SAN ANTONIO WATER SYSTEM  
DSP Southeast Tank and Pump Station Project  
SAWS Job Nos. 13-6102 (DSP) & 13-6005  
Solicitation No. CO-00006

ADDENDUM NO. 2

August 3, 2015

SAWS JOB NO. 13-6102(DSP) & NO. 13-6005  
 SOUTHEAST TANK AND  
 PUMP STATION  
 TCP LAYOUT

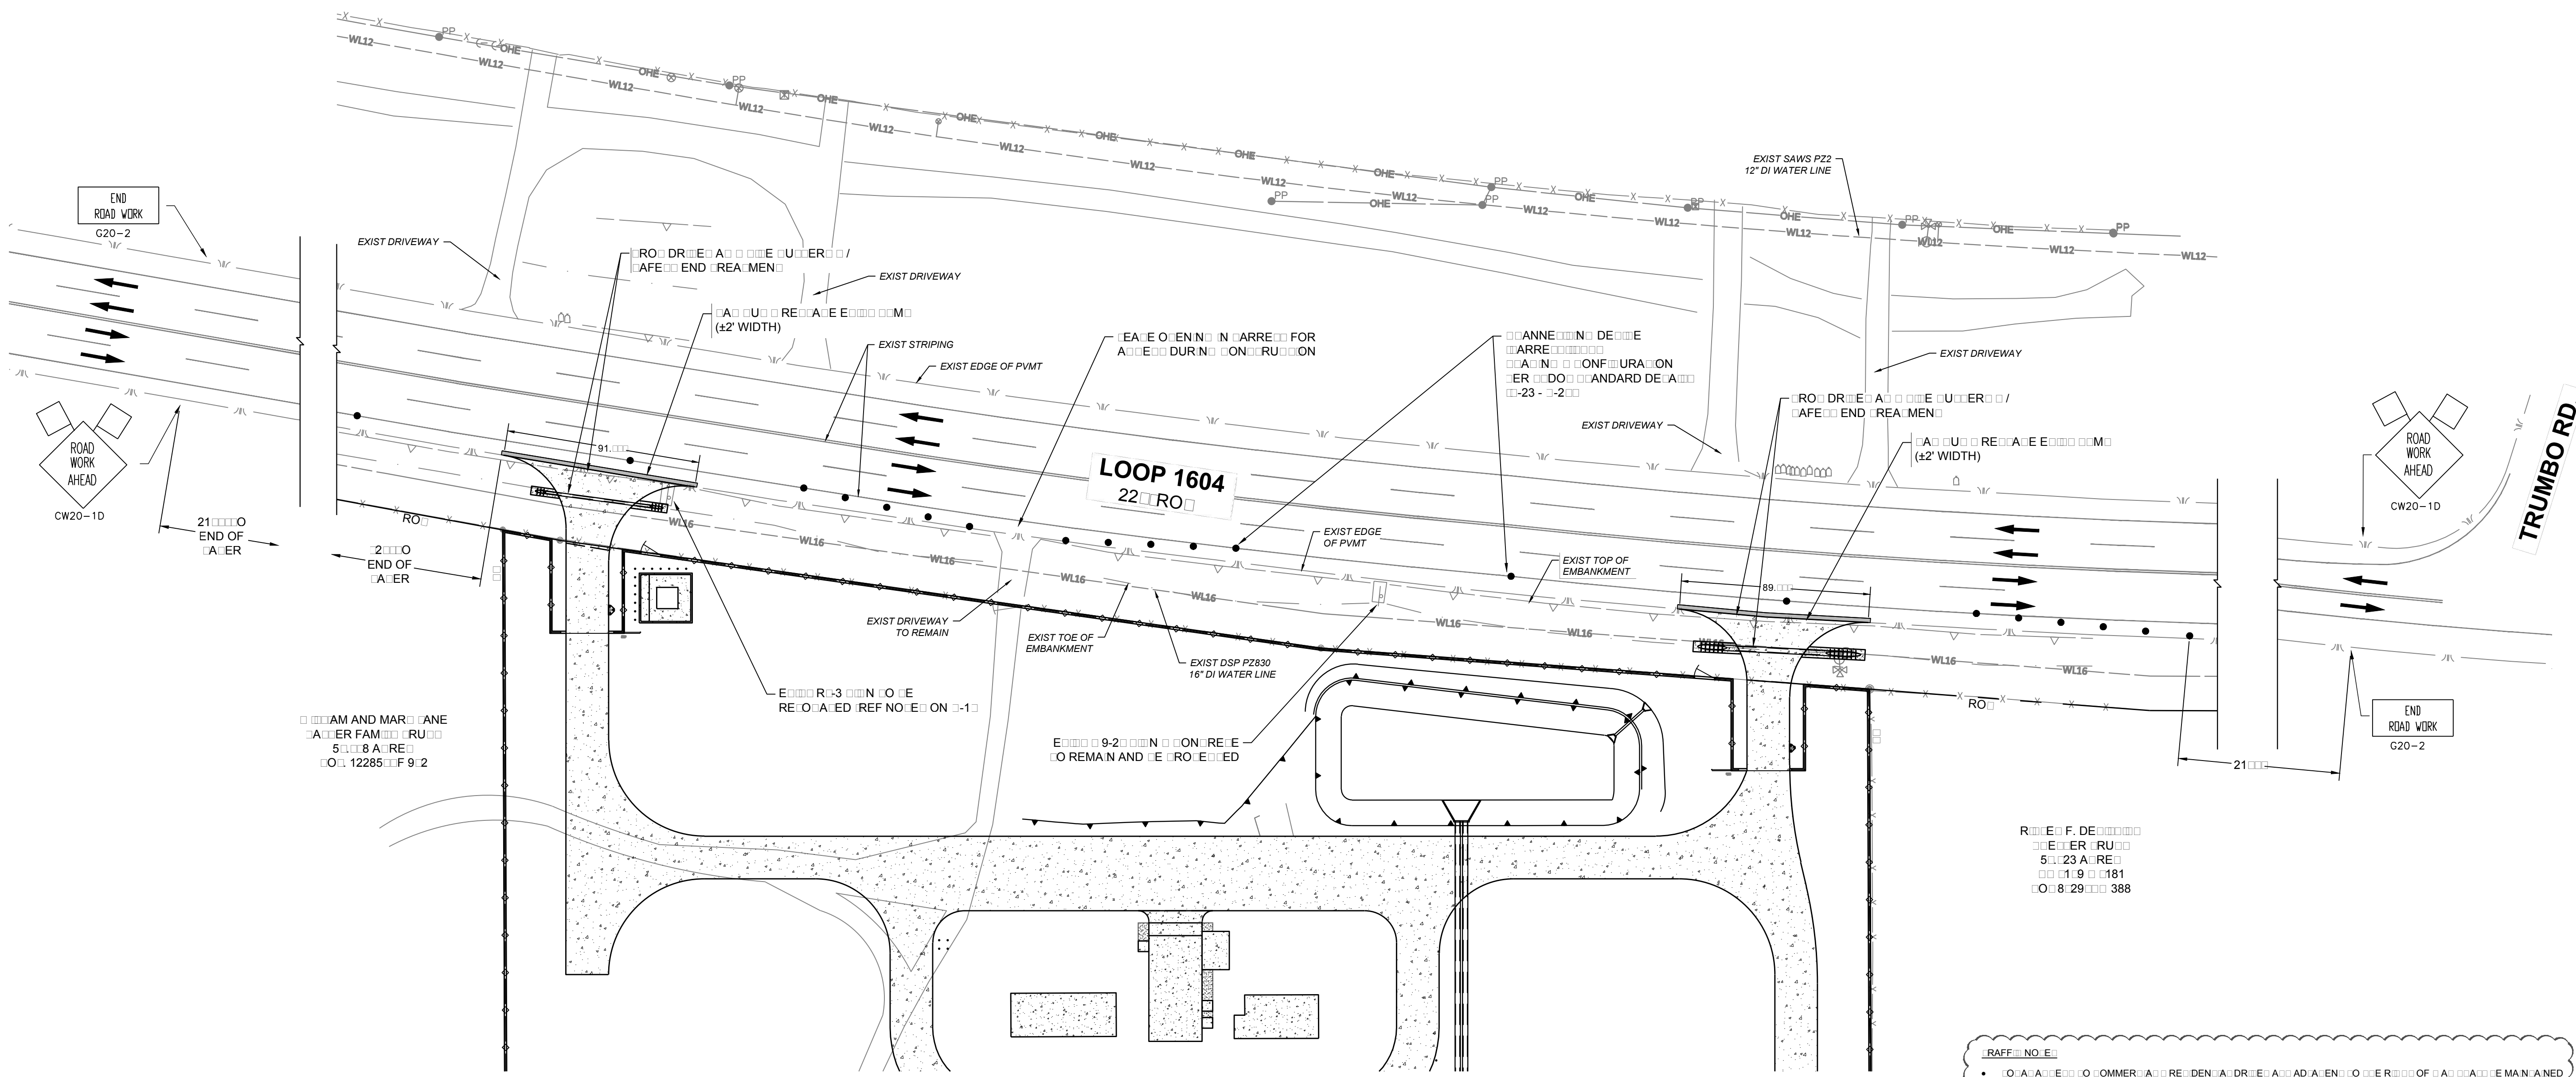
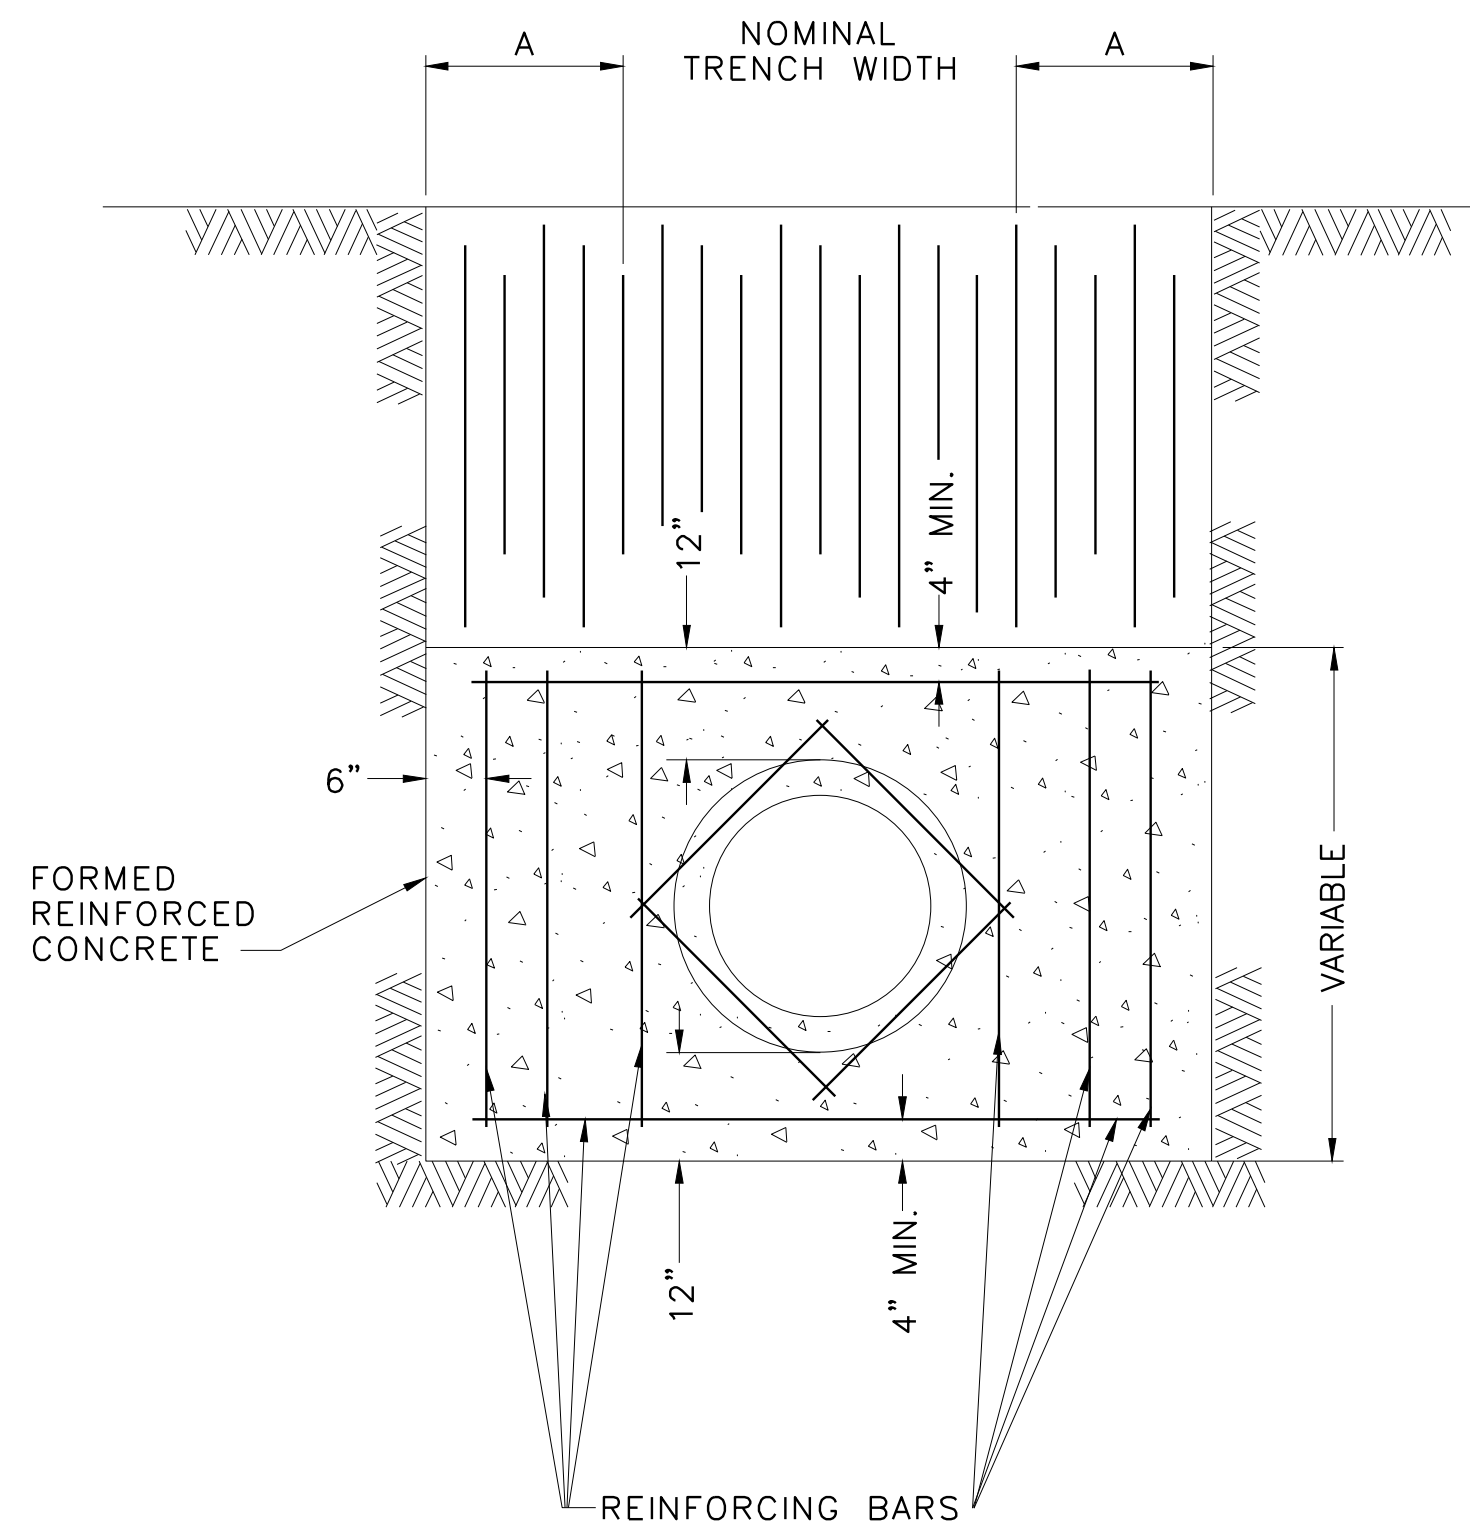
16. **Question:** Will the traffic control shown on drawings C-22 thru C-27 be required for the duration of the project? Or will this only be required when working in the TX-Dot right-of-way?

16. **Answer:** At a minimum, the traffic control measures and signage must be in place whenever working in TxDOT ROW (i.e. fence removal, utility relocation, driveway installation, etc.). Depending on how the contractor phases their work will determine the times at which the TCP measures will be needed. The contractor should coordinate with TxDOT on any required signs for site ingress and egress. Driveway permit acquisition is the responsibility of the contractor. Sheet C-22 is revised per Addendum No. 2, Part 3, Item No. 1.

SAN ANTONIO WATER SYSTEMS  
 DSP SOUTHWEST TANK AND PUMP STATION  
 ARCHITECTURE  
 CHLORINE BUILDING  
 DOOR SCHEDULE AND DETAILS

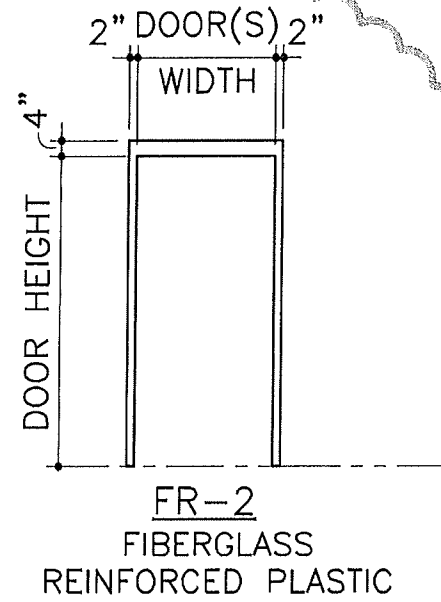
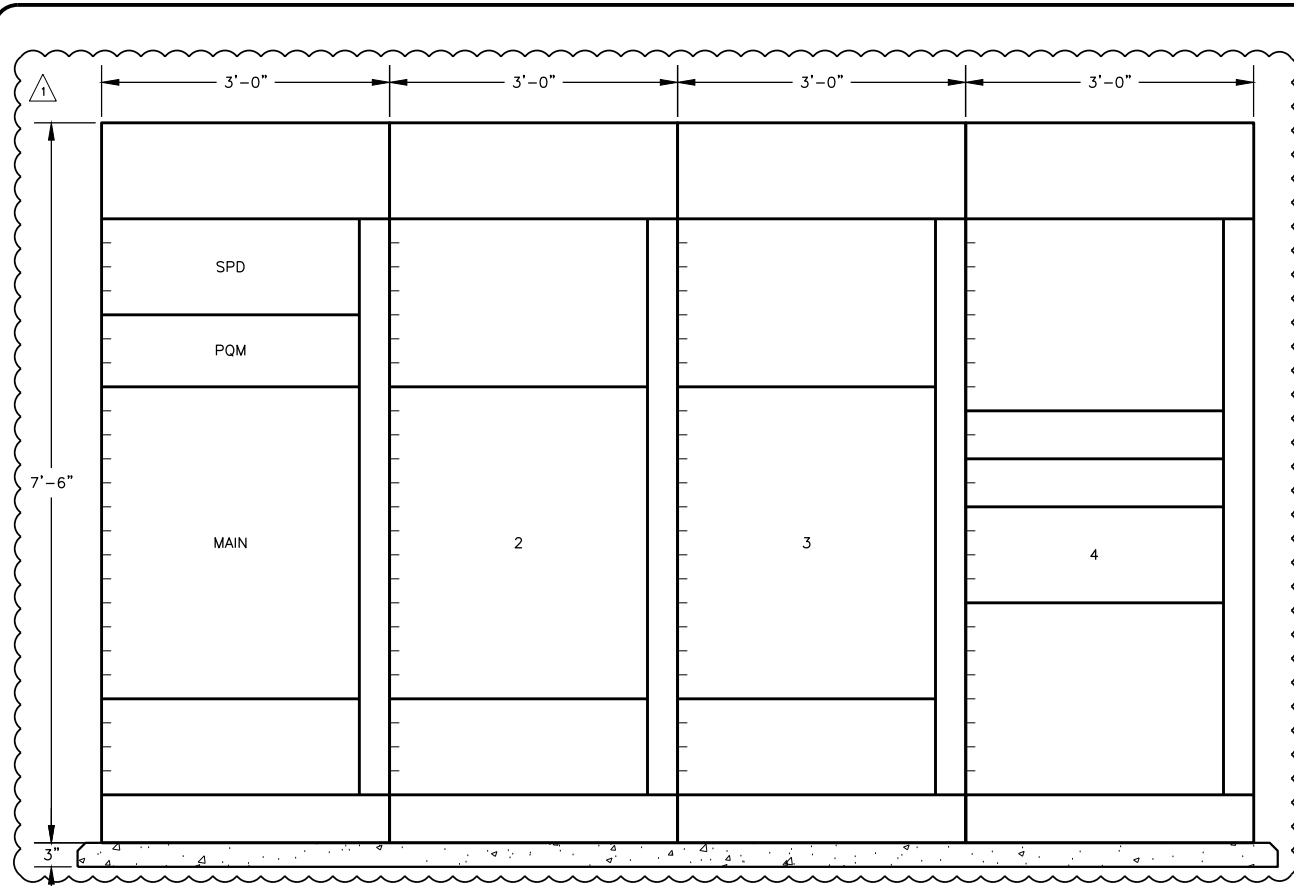
20. **Question:** Drawing A-7 lists all doors and frames to be Hollow Metal. There is a Specification section 08220 for Corrosive Resistant Doors, where are the Corrosive Resistant Doors to be installed? Please correct the Door schedule to reflect the changes?

20. **Answer:** Corrosive Resistant Doors will be installed at the chlorine building. Sheet A-7 is revised per Addendum No. 2, Part 3, Item No. 3.

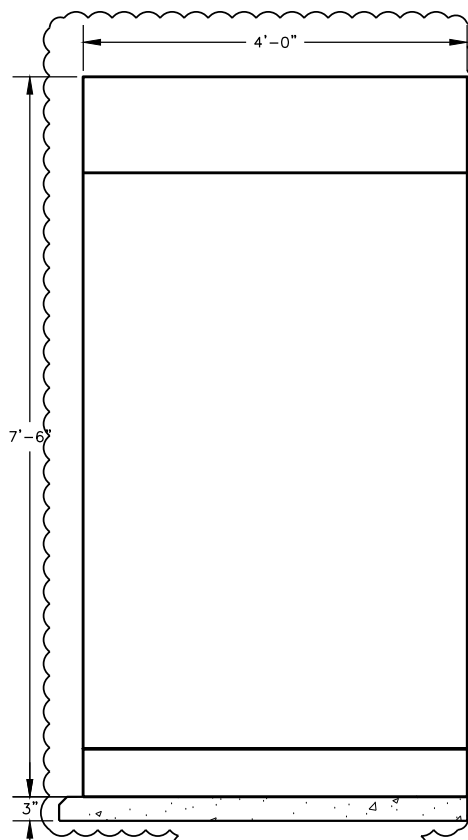
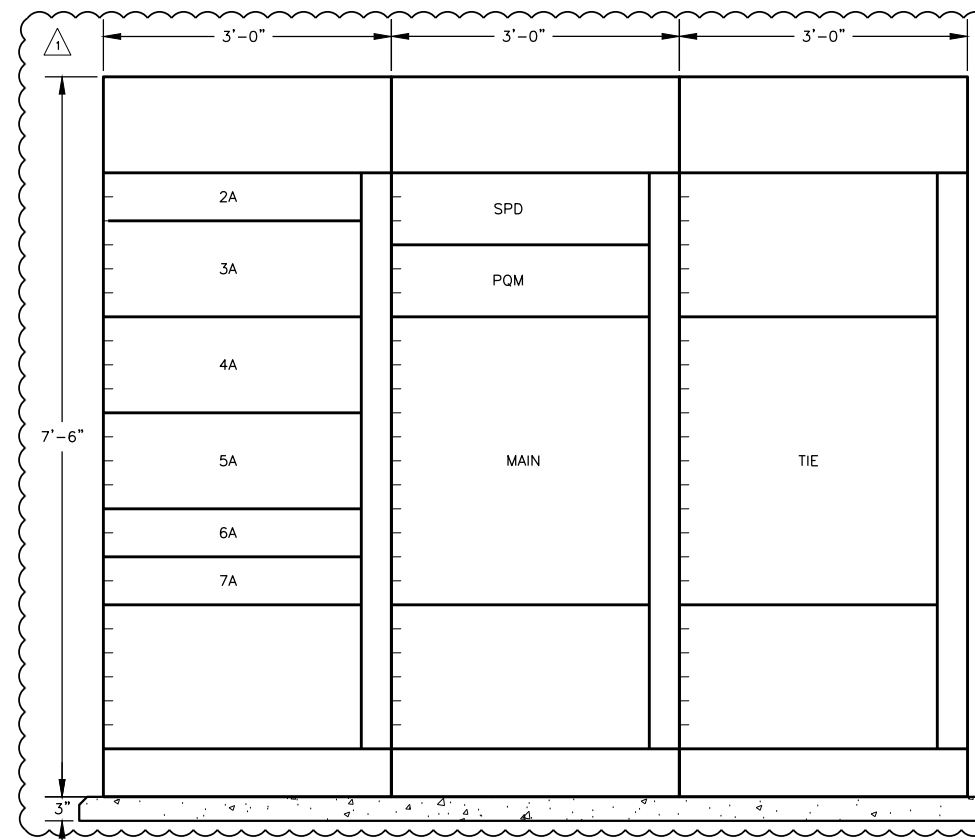
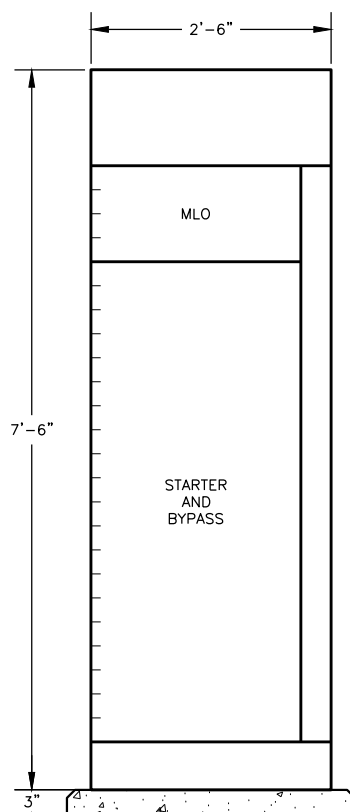
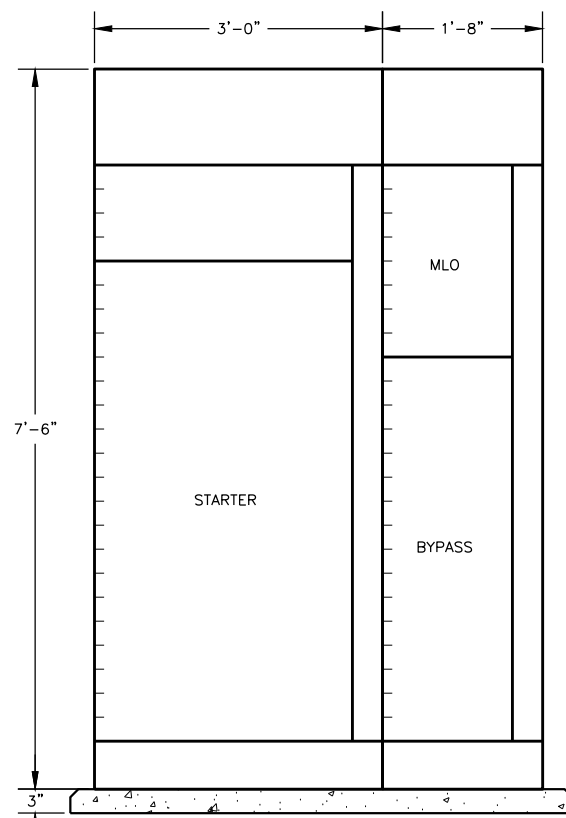
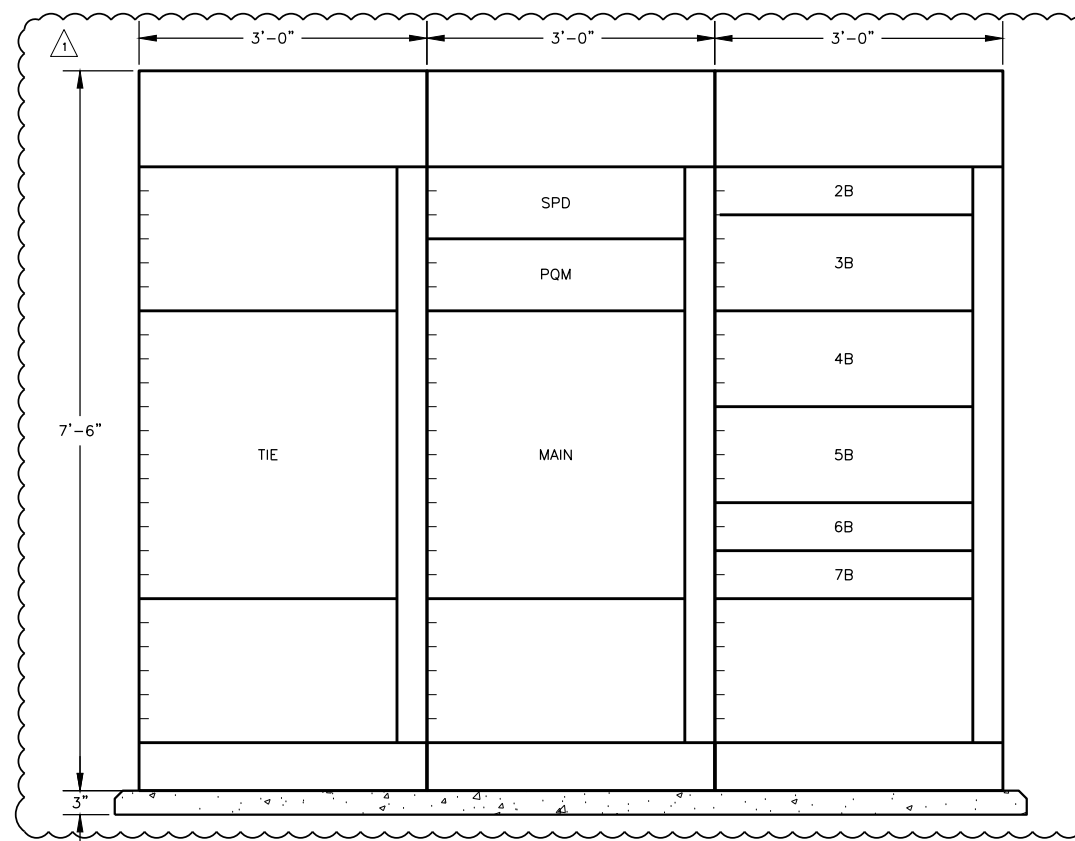
4. **Question:** Drawing E-10 shows Switchboard SA and SB having a total of 5 Sections see snap shot picture below.

Drawing E-8 has Switchboard SA with 3 Sections and Switchboard SB with 3 Sections, seems the second Tie Breaker was not taking into account in Switchboard SB see snap shot pictures below. If the Tie breaker is not to be included in Switchboard SB should the Switchboard be configured as a Main-Tie-Main Switchboard and bus Switchboard SA and SB together?

7. **Question:** Drawing E-8 SPD is shown to be in the fourth Section on the elevation drawing. Could place the SPD above the Main closer to the incoming source would this be more preferable since the SPD Cable Length should be kept as short as possible?

9. **Question:** Drawing E-8 shows the depth of Switchboard MSB as 4'-0" which would be for a Conventional UL891 Switchboard in a NEMA 1 Enclosure. The Enclosure Depth for a UL891 Compartmentalized Switchboard would be 129.25" Deep. Advise Group Mounted Design or Compartmentalized? NEMA 3R Group Mounted Switchboard Design for MSB would have floor depth of 59.5"D.

4. **Answer:** The layout for switchboards SWBD-SA and SWBD-SB are rearranged, see drawings E-8, E-10, E-12 and E-14. These changes are made under Addendum No. 2, Part 3, Item Nos. 4 through 7.

6. **Answer:** Incoming cables can come into the main circuit breaker for switchboard ‘MSB.’ See revised drawing E-8, per Addendum No. 2, Part 3, Item No. 4.

7. **Answer:** The SPDs will be mounted above main breakers, see revised drawing E-8 per Addendum No. 2, Part 3, Item No. 4.
8. **Question:** Drawing E-7 and E-8 shows the Switchboards as Conventional UL891 with Fixed Mounted Breakers, specification 16424 calls for the Switchboards to be Compartmentalized Construction with Drawout Circuit Breakers. Should the Switchboards be Compartmentalized as called for in the specification or not?

8. **Answer:** Switchboards “MSB”, “SWBD-SA” and “SWBD-SB” are conventional UL891 with fixed mounted breakers. The main and tie breakers shall be insulated case breakers type for switchboards “SWBD-SA” and “SWBD-SB.” For switchboard “MSB”, the main and 2000 Amps feeder breakers shall be insulated case breakers.

9. **Answer:** The switchboard "MSB" is conventional UL891, group mounted in NEMA 3R construction. The pad size shall be adjusted for the equipment submitted.

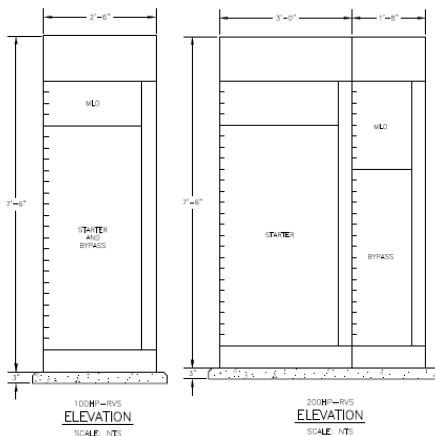
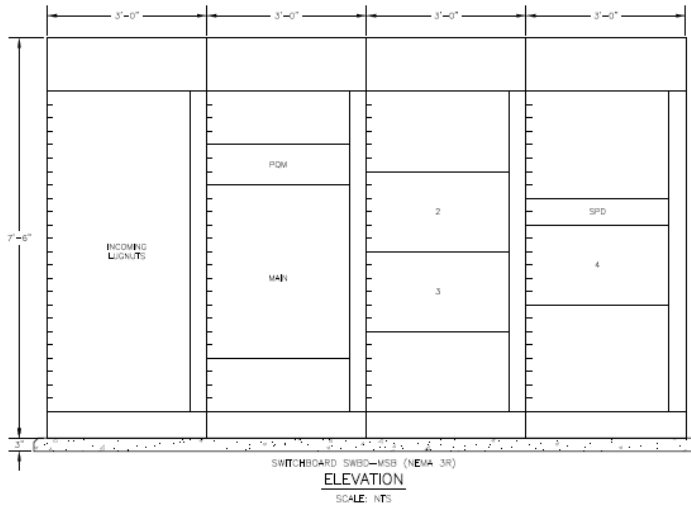
5. **Question:** Drawing E-8 has the RVS Units in a Motor Control Center Design. Can these Units be provided as Enclosed Panel Mounted Design such as in a Hoffman and or similar enclosure in lieu of MCC? See Snap Shot on how currently depicted on Drawing E-8.

5. **Answer:** The RVS units can be mounted in enclosed panels as long as these units can fit in allocated spaces.
6. **Question:** Drawing E-7 and E-8 has Switchboard MSB shown as a conventional UL891 Switchboard with an Incoming Lug Section. Incoming Cables can come into the Main Breaker Compartment eliminating the Incoming Lug Section, can this be provide without the Incoming Lug Section?
